## Museet for Danmarks Frihedskamp 1940-45

**Museum of Danish Resistance 1940-45**

Indbudt projektkonkurrence, København  
Dommerbetænkning, maj 2015

Restricted design competition, Copenhagen  
Assessment panel report, May 2015

Plan 01

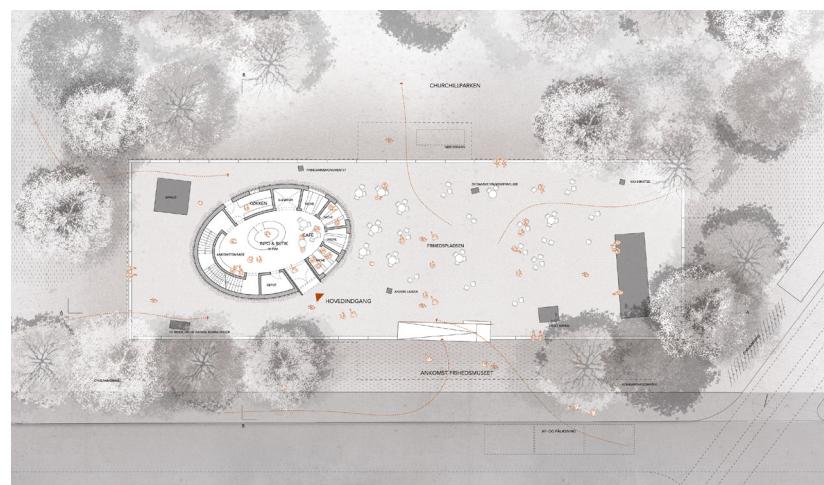
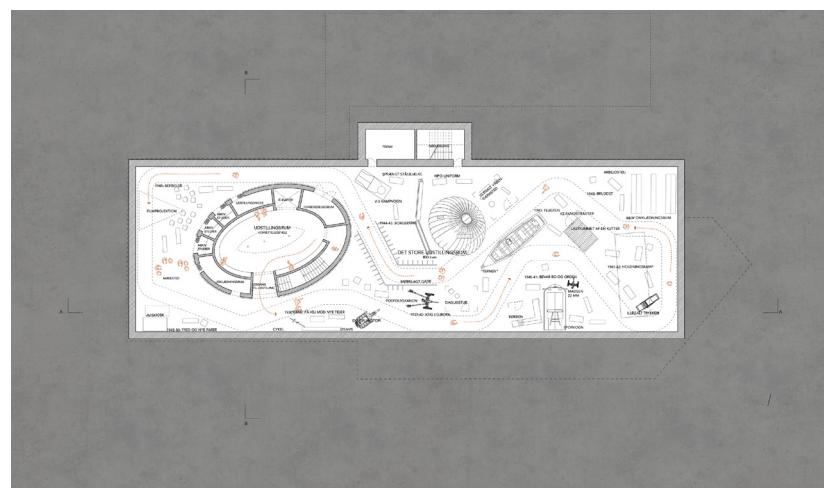
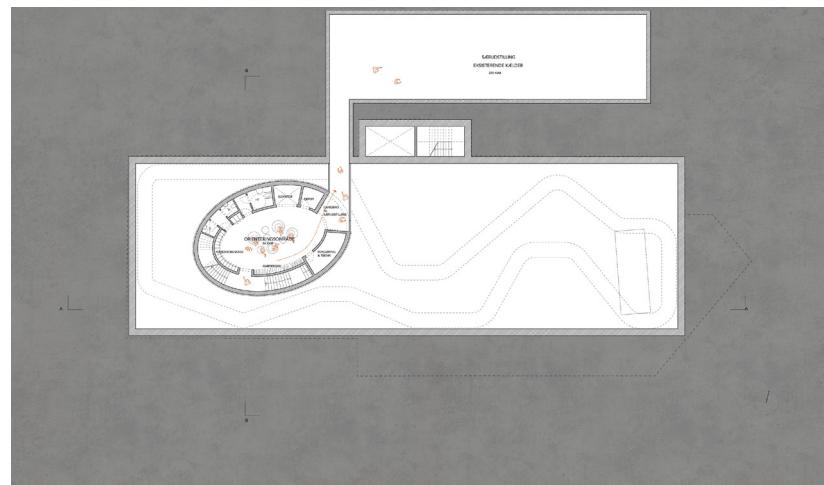
Hovedankomsten til museet sker via en rampe placeret mod Esplanaden. Rampen markeres ved et murforløb med navneinskription. Yderligere to ramper placeres, så der skabes tilgængelighed. Det er dog uklart, hvordan vareindlevering og affaldshåndtering sker via disse ramper. I en videbearbejdning skal dette kvalificeres.

Affaldsrummet er vist som en selvstændig figur i plantegningen men er ikke nærmere beskrevet eller illustreret. Det ønskes belyst, hvordan figuren kan indgå i den enkle komposition mellem ankomstbygningen og rammen, og om det eventuelt er muligt, at det integreres i ankomstbygningen.

Der er i dommerkomiteen bekymring for, at den sørnede grusflade vil virke som et vandkar ved ekstrem regn. I den videre bearbejdning skal det kvalificeres, hvordan rammen og fladen kan bearbejdes, så der ikke er risiko for indtrængning af vand. Bearbejdningen skal ske uden, at rammen mister sin unikke karakter og evne til at være både åben, inviterende og introvert på samme tid. Ankomstbygningens beplantning er en poetisk og smuk tanke. Der skal dog vælges en beplantning, som er robust nok over for vejrlig, og som kun kræver optag af naturligt regnvand, da det er påkrævet ikke at bruge vandingssystemer på facaden, som kan give risiko for vand i udstillingen under jorden.
